IMGS 2003 REPORT

The geological and structural characterization of
the Olkiluoto site in a critical perspective

COSGROVE John (Imperial College), JOKINEN Jarkko (GSF), SIIVOLA Jaakko (ex Helsinki University), TIRÉN Sven (GEOSIGMA AB). IMGS 2003 Report. The geological and structural characterization of the Olkiluoto site in a critical perspective. STUK-YTO-TR 205. Helsinki 2004. 27 pp.

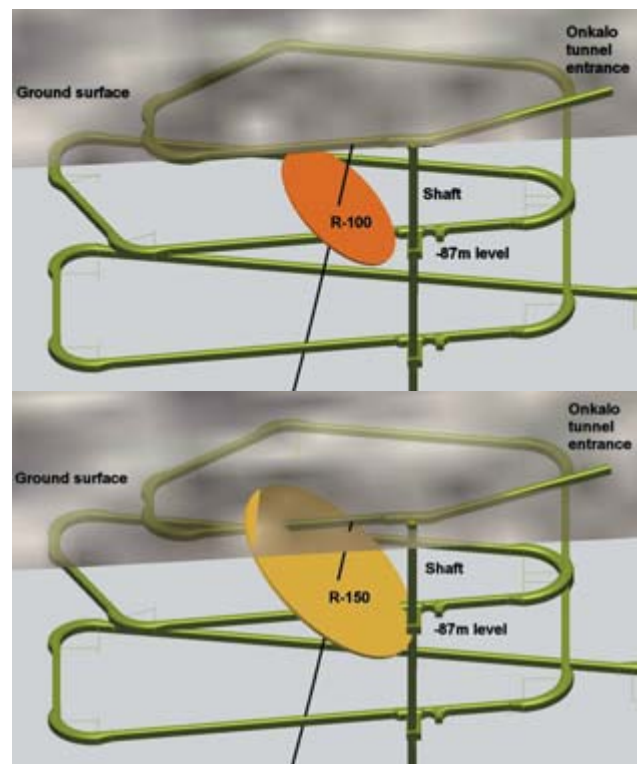
The IMGS Group considers that the procedure for representing the structures as 100m radius discs and not extrapolating them beyond this limit is likely to result in a significant underestimation of the number of intersections of these structures and hence the connectivity and conductivity of the resulting fracture network. This they argue will result in an unacceptable oversimplification of the structural model. The rationale used for constraining the structures to 100m radius discs needs clarification (Fig. 2).
